ARVA PUMPING STATION TO HURON STREET WATER TRANSMISSION MAIN ENVIRONMENTAL IMPACT STUDY, MAY 20, 2021 BY AECOM

Received at EEPAC's May 2021 meeting

Reviewed S. Heuchan, S. Levin, and K. Moser

Figure 1: Locations of (from left to right) Chamber 12 MAIN, Chamber 12A and Chamber 13. The red pins show locations of chambers.

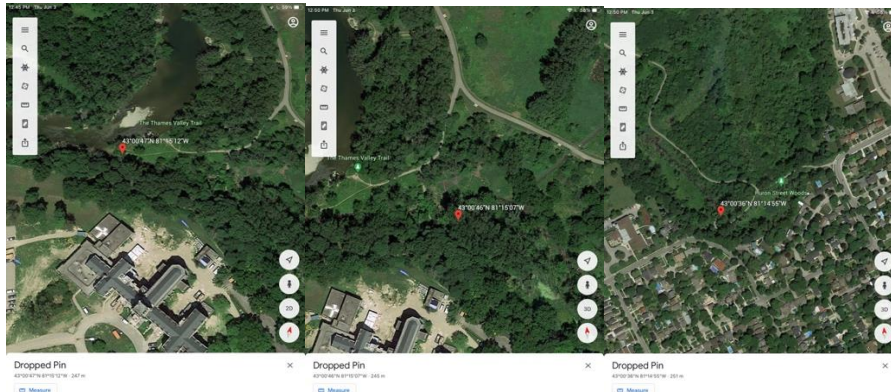
Attached are Google Earth images of where we think these chambers are located. The first is no more than 20-30m from the Thames. The first photograph after the maps shows the site. We believe this is Chamber 12 MAIN and is not correctly shown on the AECOM map contained in the EIS. The second site (chamber 12A) is at the base of the hill that heads up to the seminary. It is off the trail and in mature trees. The second map and second photo show the site. It appears that Chamber 12A is located approximately correctly and chamber 13 is correct on the AECOM map. The last photo shows an invasive Iris located just adjacent to the chamber 12A site. <https://www.ontario.ca/page/yellow-iris>.

RECOMMENDATION J: The EIS show the correct locations of each chamber.

RECOMMENDATION K: Replanting native trees or other native plants in “beat up” area to the east of chamber 12 Main.
